Council Reference: DA09/0701.03 LN35979
Your Reference:

**TSC Submission Altitude Aspire Residential Subdivision
MP09/0166 MOD 3 (Council Reference DA09/0701.03)**

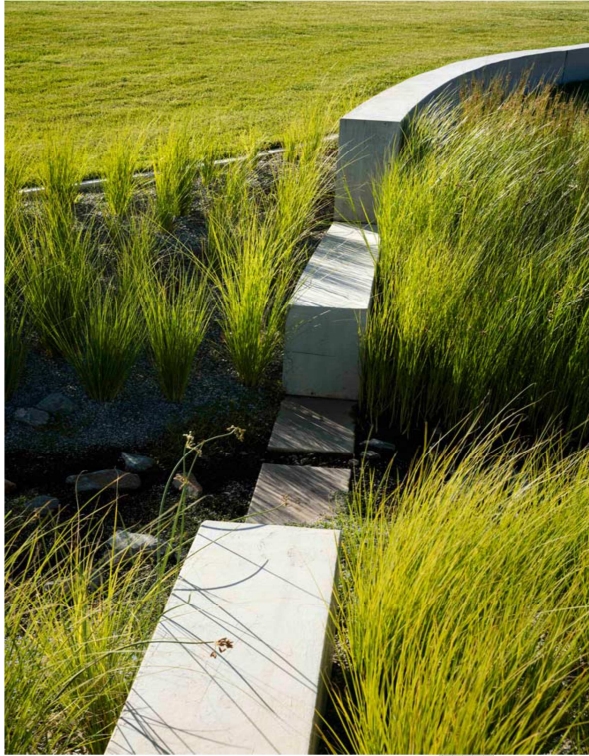
To facilitate any pedestrian access through this Drainage Reserve, all pathways should be elevated (with handrails) above Q100 year level, using non-timber structures (eg: recycled plastic). The extent of such a pathway network should however be minimised. This should be the desired outcome, which also opens up possibilities for visually appealing treatments of drainage features.

To this end the following photos are example treatments of other major waterway conveyance areas with associated pedestrian accessways. These are provided to encourage alternative design treatments that could create a visual centrepiece for this Estate. It is however reiterated that public safety issues and ease-of-maintenance need to be major design considerations.
